City of Surrey
PLANNING & DEVELOPMENT REPORT

Application No.: 7915-0452-00

Planning Report Date: April 20, 2020

RESPONSE TO ADP MINUTES :

| Project Title | SITE PLAN & PARKING CALCULATION | | |

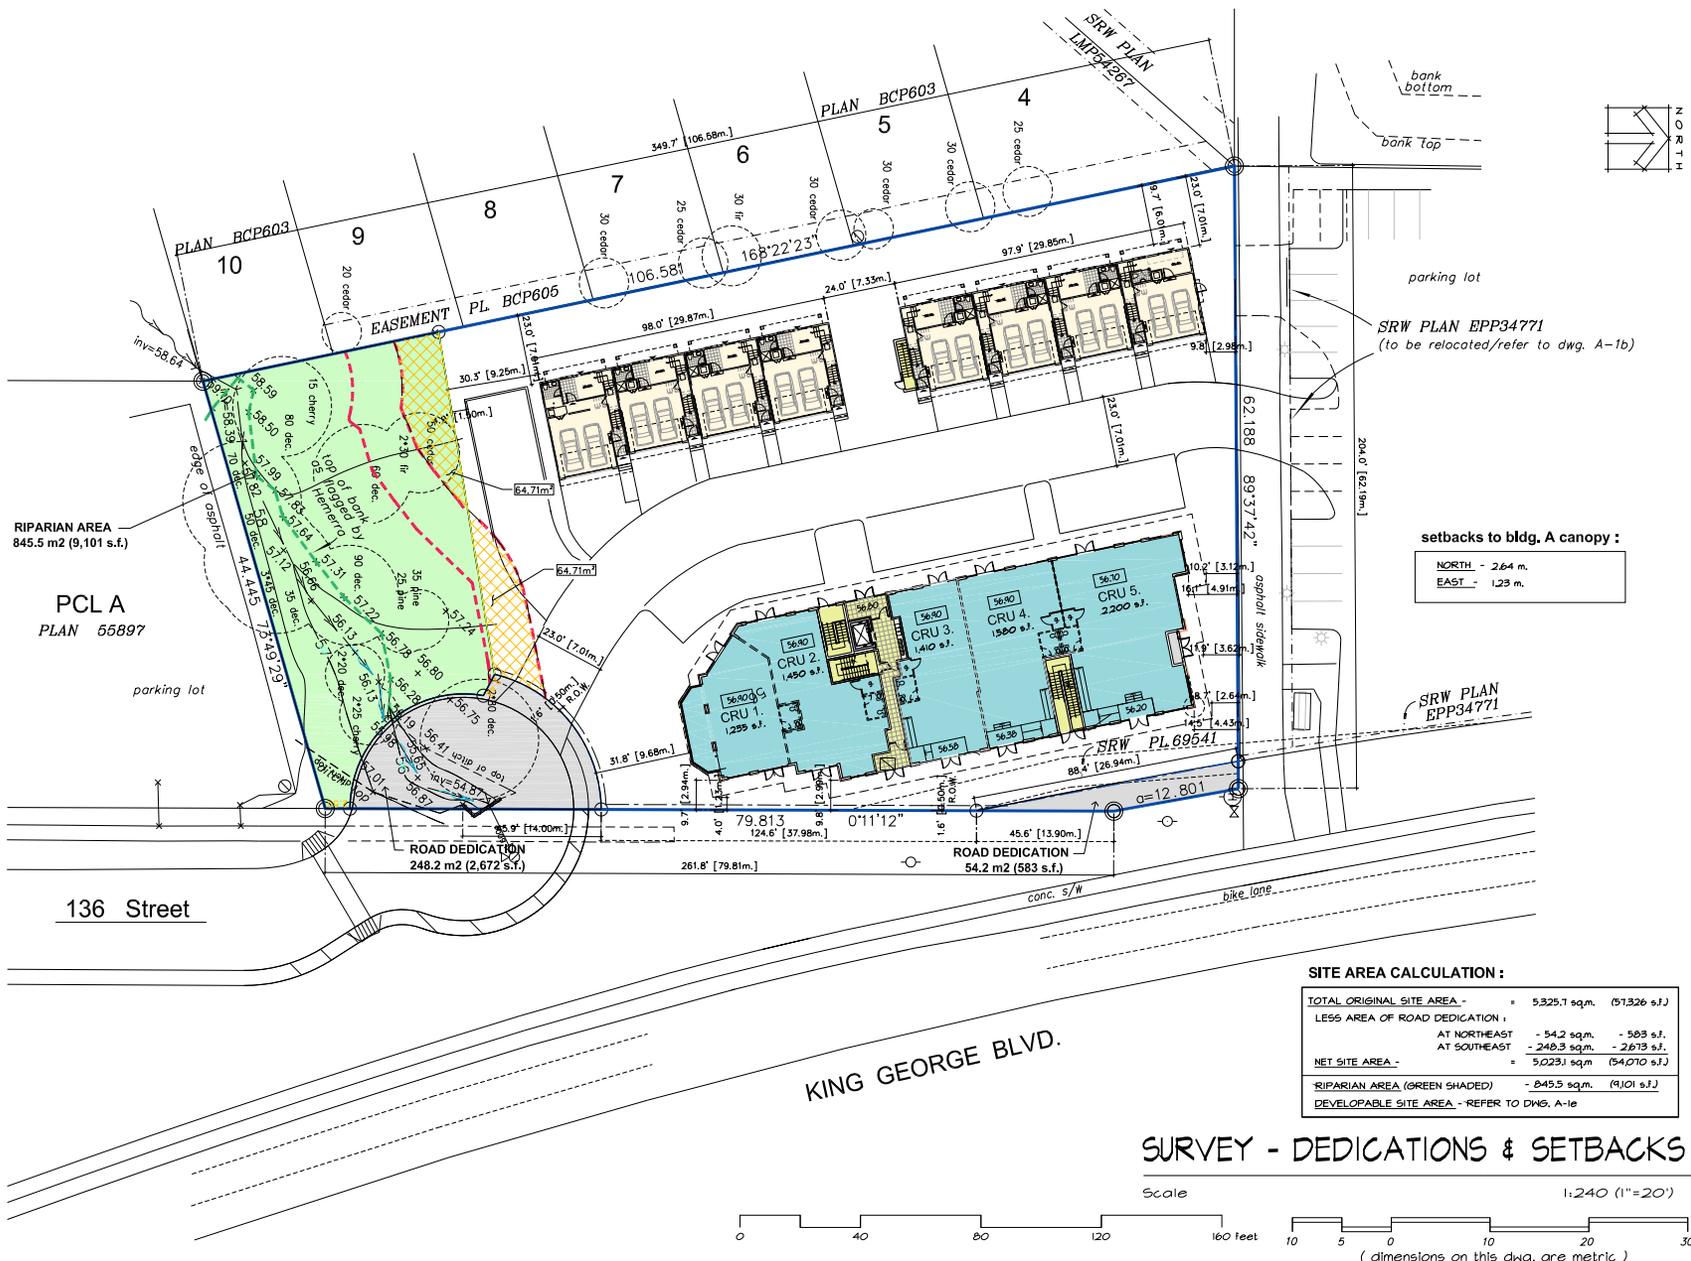
- . - refer to site plan dwg. A-2
- . • Consider townhouse bay expressions A and B proportions.
- . - alternating units have different garage doors, entrance doors and bay window roofs.

Sheet of A-8
 Date: JULY 2019
 Revision: Project No. 14-1475
 05

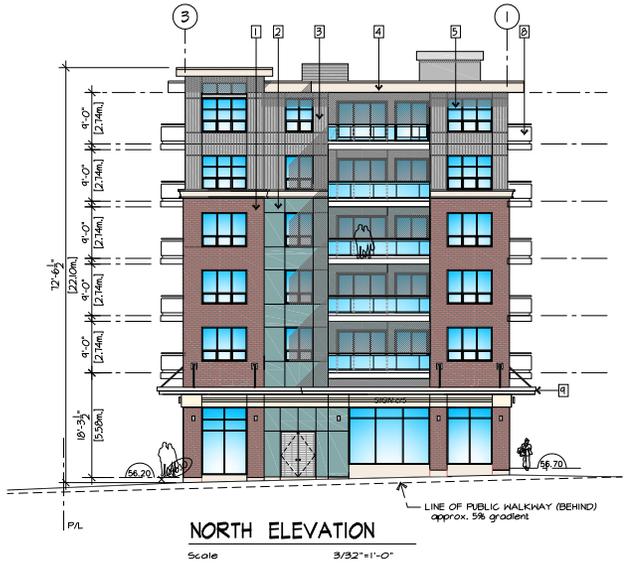
- . - refer to drawing A-8
- . • Consider private roof deck for top floor units.
- . - this idea has been considered but not taken partially out of consideration for the single family neighbours to the west who have expressed concern with loss of privacy due to overlook overlook. As well all the apartment units have generous balconies as well as access to the amenity area outdoor decks.

- . • Reconsider massing of south east corner.
- . – changes have been made, refer to response previously and drawing A-8.
- . • Recommend further design development to north/south elevation as primary approaches for the public and 'address' of apartment building.

- . – 'orphaned' brick features have been deleted (changed to Hardie), Hardie has been revised per this and next comment.
- . • The use of the contiguous Hardie material from bottom to top over emphasises the massing. Consider differentiating the lower part of the building by making a clear demarcation of the top-middle and top.

- . – see response to previous comment.
- . • Consider lighter in colour to diminish the volume presence of the upper floors.
- . – upper two floors will be clad in Hardie Cobblestone.
